**Safety Defect and Noncompliance Report Guide for Vehicles**  
**PART 573 Defect and Noncompliance Report<sup>1</sup>**

On April 12, 2004, Sutphen Corporation[MFR] determined that (a defect which relates to motor vehicle safety)(a noncompliance with Federal Motor Vehicle Safety Standard No. 121) exists in the motor vehicles listed below, and is furnishing notification to the National Highway Traffic Safety Administration in accordance with 49 CFR Part 573 Defect and Noncompliance Reports.

04V-277  
(13 pages)

There is a possibility that (3) air lines running to the chassis E-7 brake treadle valve have, been routed incorrectly.

PIC1

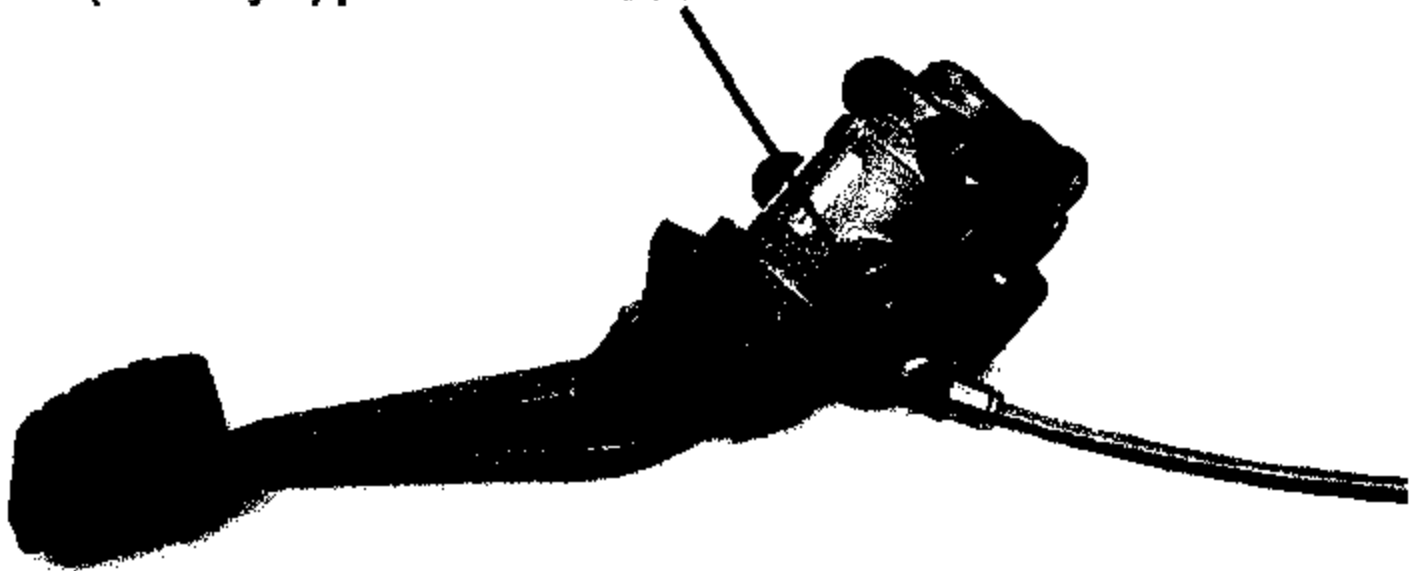
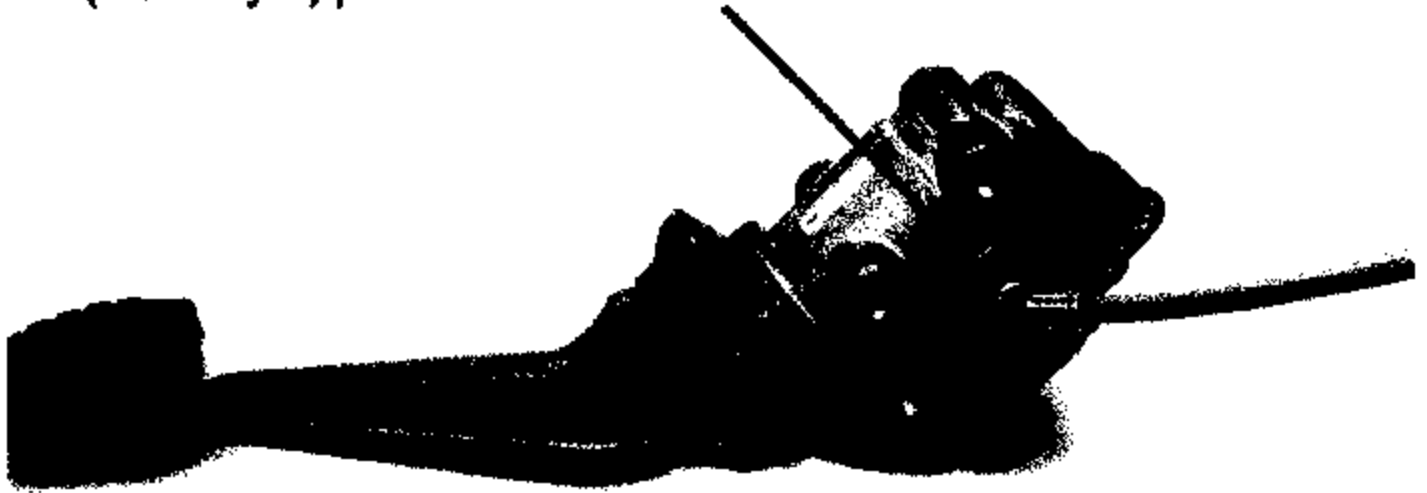
**INCORRECT** location of the green control line plumbed into the D-1 (Delivery 1) port on a Tilt Cab.

**CORRECT** location of the green control line plumbed into the D-2 (Delivery 2) port on a Tilt Cab.

1. Locate the green 3/8" control line on the right side of the E-7 brake treadle valve on a tilt cab or on the left side for a fix cab.
2. Disconnect the green line and remove the plug either above or below where the green line was plumbed

3. Depress the brake pedal and deplete the air in the truck.
4. With a finger in each of the delivery ports, where the green line and plug were removed, start the truck and with the brake pedal depressed, identify which port builds air first.

5. If the lower port, which is D-1 (Delivery 1), builds air first, this tells you that the supply lines are plumbed correctly.
  - a. Plug the lower D-1 port and connect the green control line to the upper D-2 port.

- b. Perform line 2 through 5 of the following re-test procedure.
6. If the upper port, which is D-2 (Delivery 2), builds air first, this tells you that the supply lines are reversed and the following repair needs to be performed.

PIC2

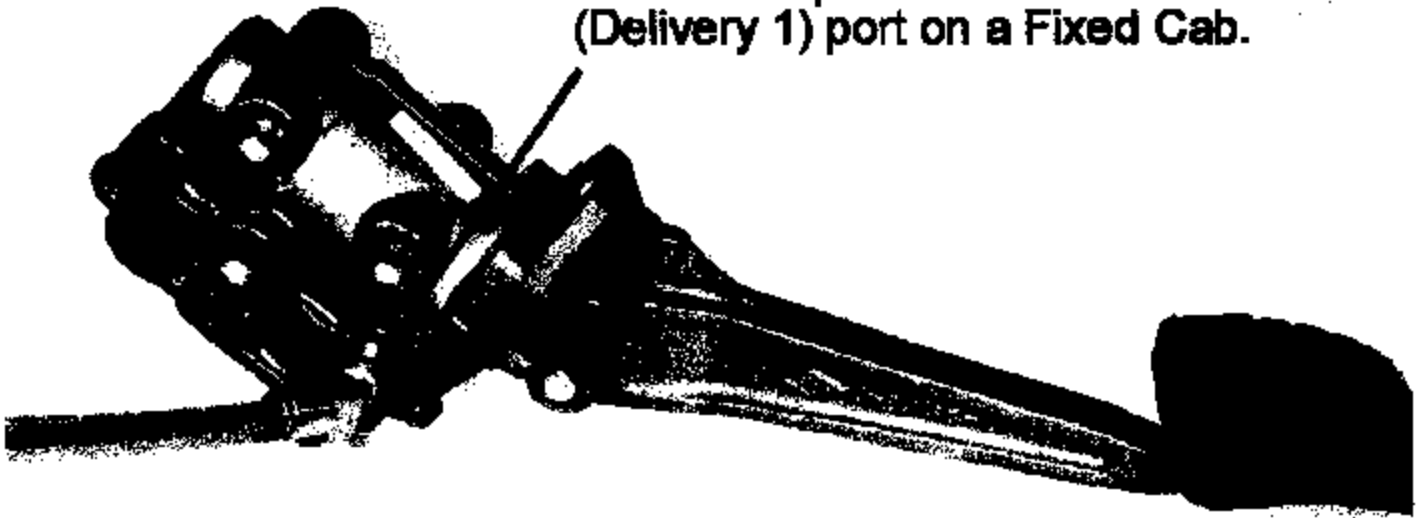
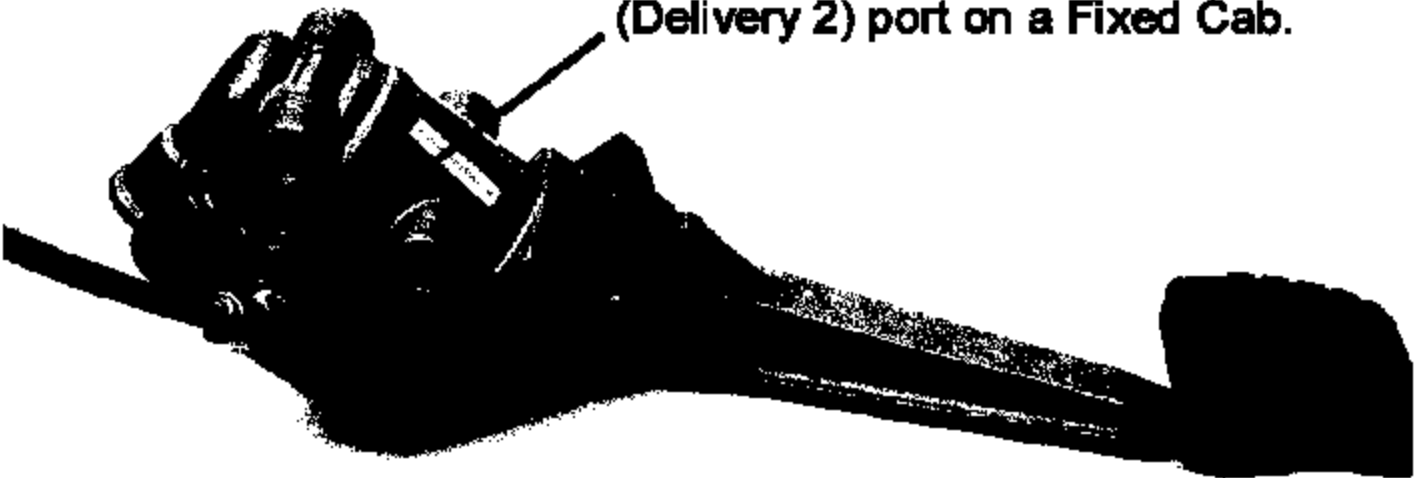
**INCORRECT** location of the green control line plumbed into the D-1 (Delivery 1) port on a Fixed Cab.

**CORRECT** location of the green control line plumbed into the D-2 (Delivery 2) port on a Fixed Cab.

PIC5

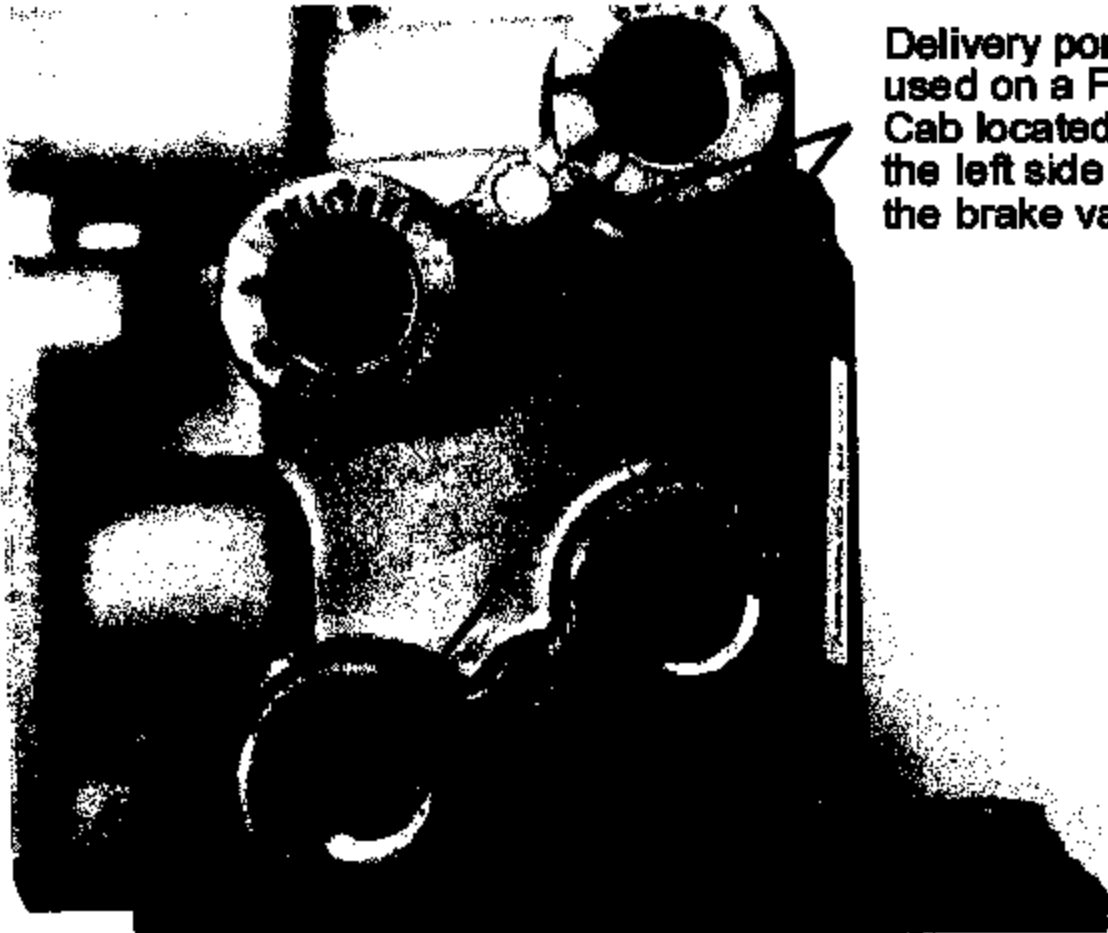
**Delivery ports** used on a Fixed Cab located on the left side of the brake valve.

PIC6

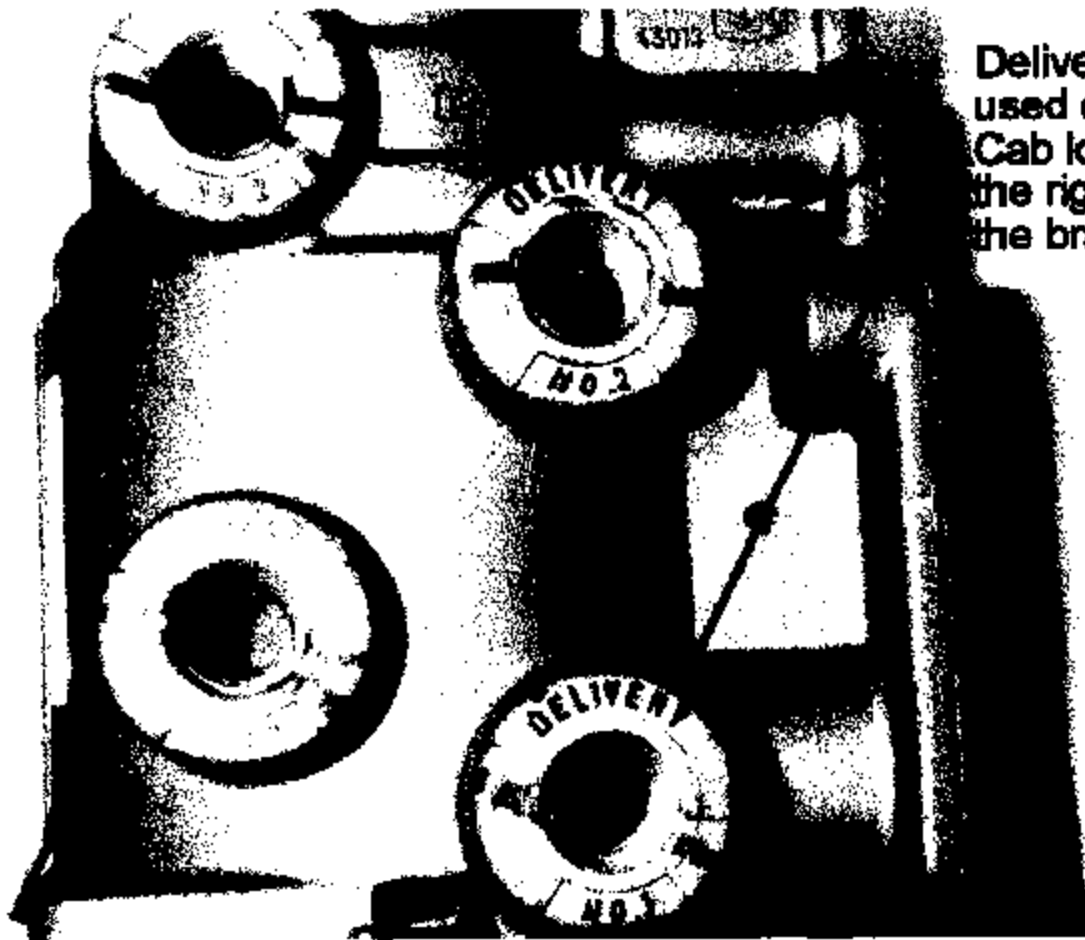
Delivery ports  
used on a Tilt  
Cab located on  
the right side of  
the brake valve.

PIC7

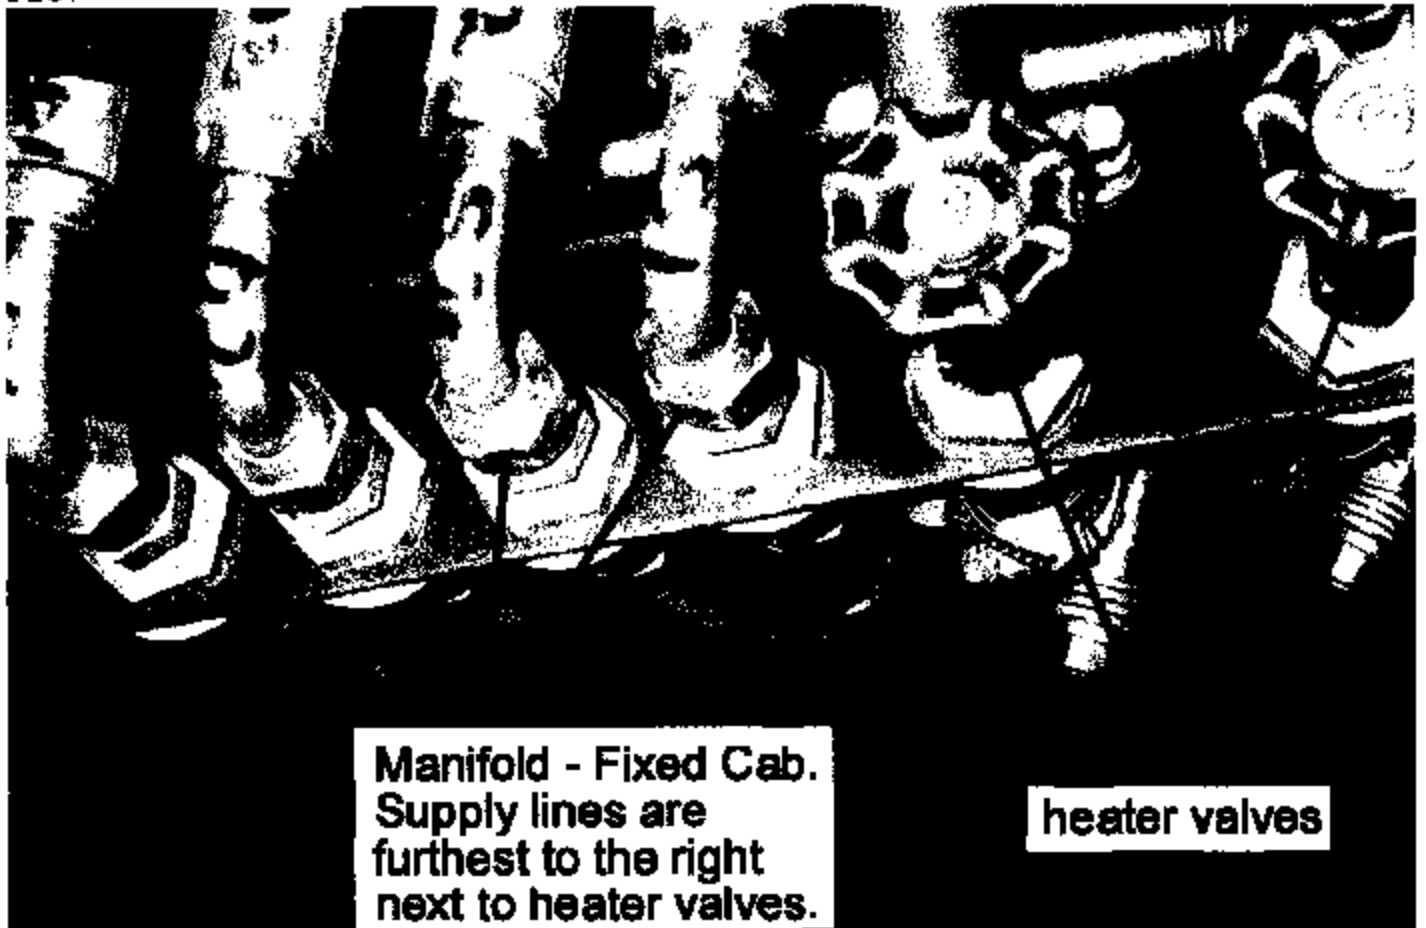
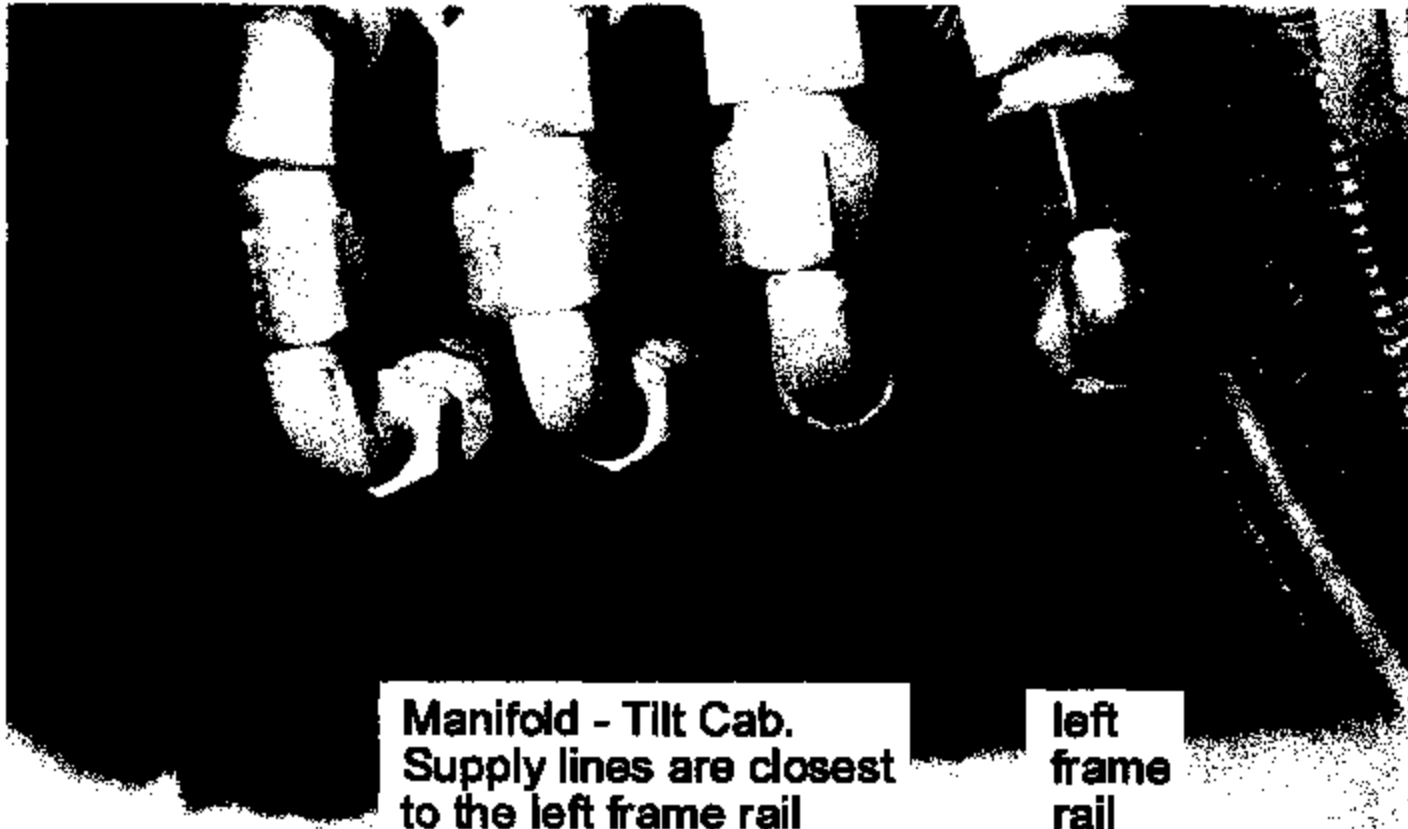
Manifold - Fixed Cab.  
Supply lines are  
furthest to the right  
next to heater valves.

1. At the brake manifold at the front of the skid plate located under the front of the truck, locate the two supply lines
2. When facing the manifold, the two supply lines are the ones farthest to the right, next to the frame rails. Exchange the location of these supply lines.  
NOTE: On the newer trucks these lines are color-coded. To prevent someone from switching them back, color-code the lines on the other side of the bulkheads using yellow and blue tape. This is extremely important, because if the lines were to be switched back with the control line in the secondary port of the brake treadle valve, the secondary braking would be disabled.
3. Perform steps 1 through 5 of the following re-test procedure.

PIC1

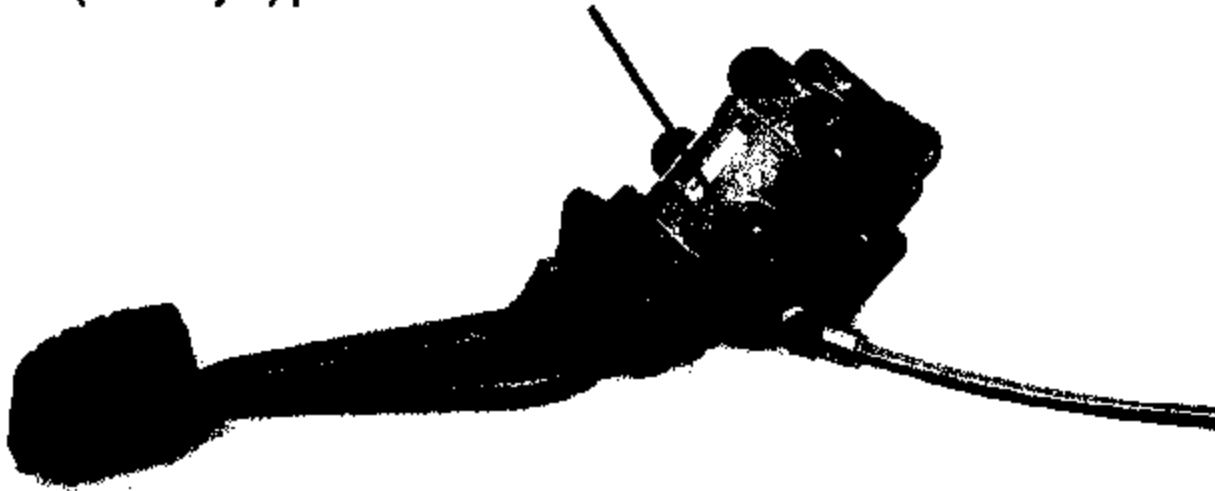
A corrected E-7 Valve control line will be connected to the D2 port whereas a non corrected E-7 would have the control line connected to the D1 port. Reference PIC1 through PIC4 below.

**INCORRECT** location of the green control line plumbed into the D-1 (Delivery 1) port on a Tilt Cab.

PIC2

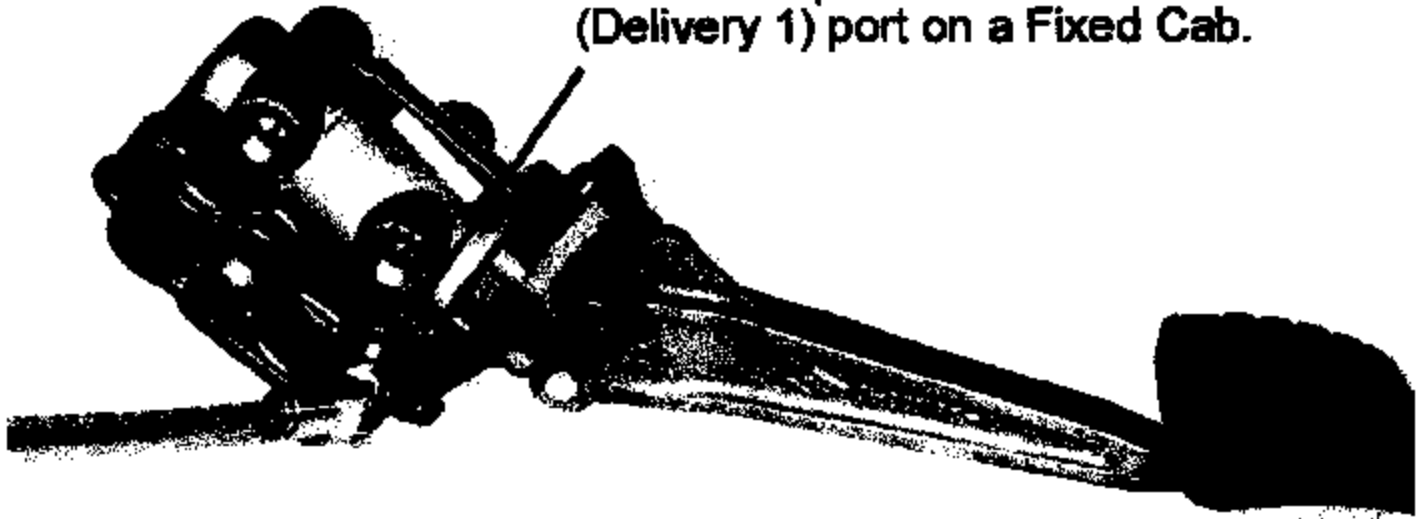
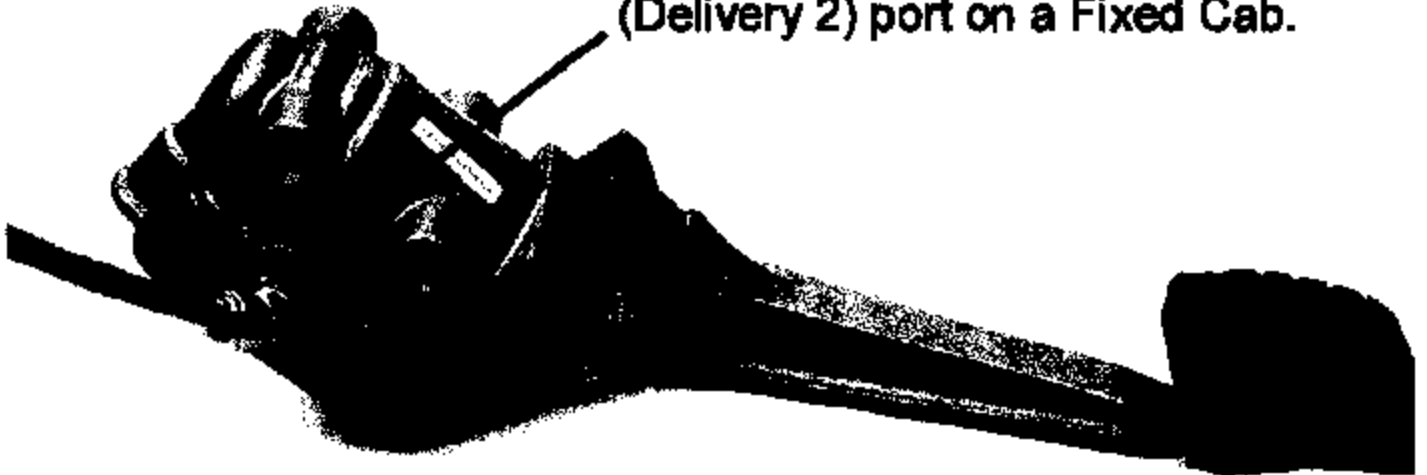
**INCORRECT** location of the green control line plumbed into the D-1 (Delivery 1) port on a Fixed Cab.

**CORRECT** location of the green control line plumbed into the D-2 (Delivery 2) port on a Fixed Cab.
